ATTACHMENT I

Proposed Technical Specification Changes

JOSEPH M. FARLEY NUCLEAR PLANT
TECHNICAL SPECIFICATION
UNIT NO. 1

FIGURE 4.6-1

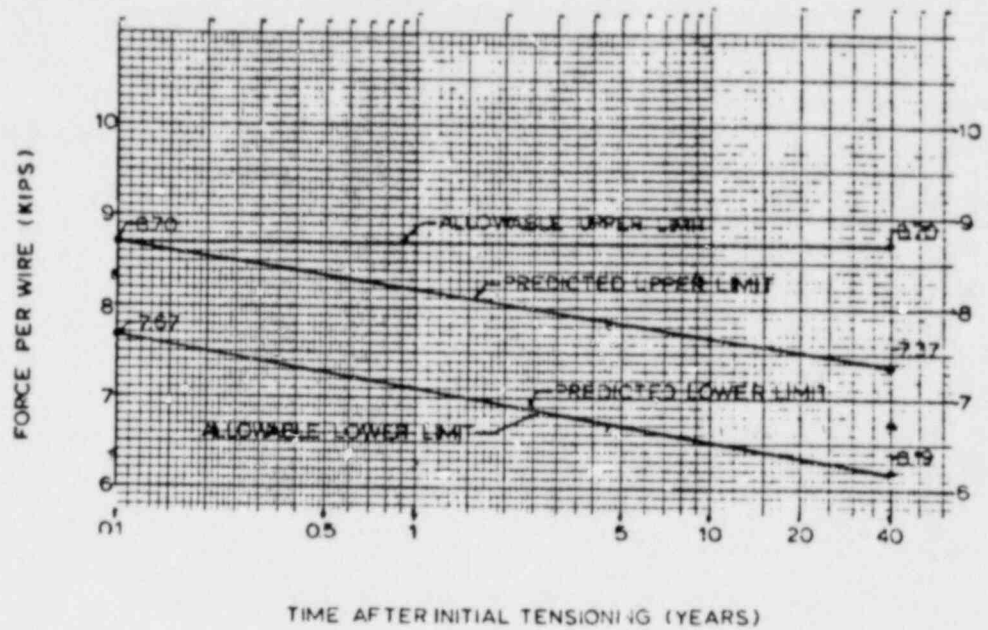
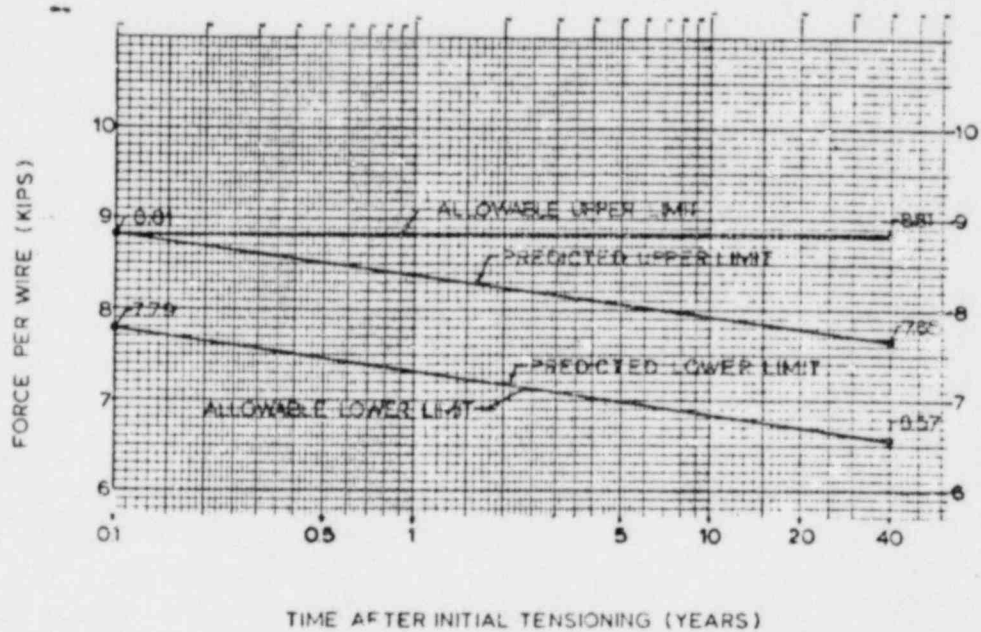
ACCEPTANCE LIMITS
TENDON WIRE LIFT-OFF
FORCE VERSUS TIME

BASES OF LOAD VERSUS TIME CURVES

INITIAL LOCK-OFF FOR TENDON STRESSES CAN RANGE FROM .70 TO .73 f_s ('a' IN THE FORMULA BELOW), OR 8.25 KIPS / WIRE TO 8.80 KIPS / WIRE.

CALIBRATION OF THE STRESSING DEVICE IS $\pm 2\%$ TRACEABLE TO A NATIONAL STANDARD. ACTUAL WIRE FORCES ARE ACCURATE TO $\pm 2\%$, HOWEVER, IF DIFFERENT DEVICES OR THE SAME DEVICE CALIBRATED BETWEEN TWO SURVEILLANCE PERIODS ARE USED ON THE SAME TENDON IN TWO SURVEILLANCES, THERE WOULD BE A POSSIBLE 4% SPREAD BETWEEN READINGS OF THE SAME TENDON LOAD. THUS, THE BAND FOR LOAD READINGS IS INCREASED TO $\pm 4\%$ ('K' IN THE FORMULA BELOW).

AN AVERAGE ELASTIC SHORTENING LOSS ('e' IN THE FORMULA BELOW) MUST BE DEDUCTED FROM THE INITIAL FORCE PER WIRE DUE TO SEQUENTIAL STRESSING OF THE TENDONS.

THE COMBINATION OF LOSSES DUE TO CREEP AND SHRINKAGE OF THE CONCRETE, AND STEEL RELAXATION VARIES DUE TO THE RANGES OF THE VARIABLES SHOWN IN THE TABLE BELOW.

AT FORTY YEARS, $fw_f = fw_i - A_w [(K_c \times E_s \times \epsilon_c / \epsilon_c') + (E_s \times E_s) + (r \times f_s)]$
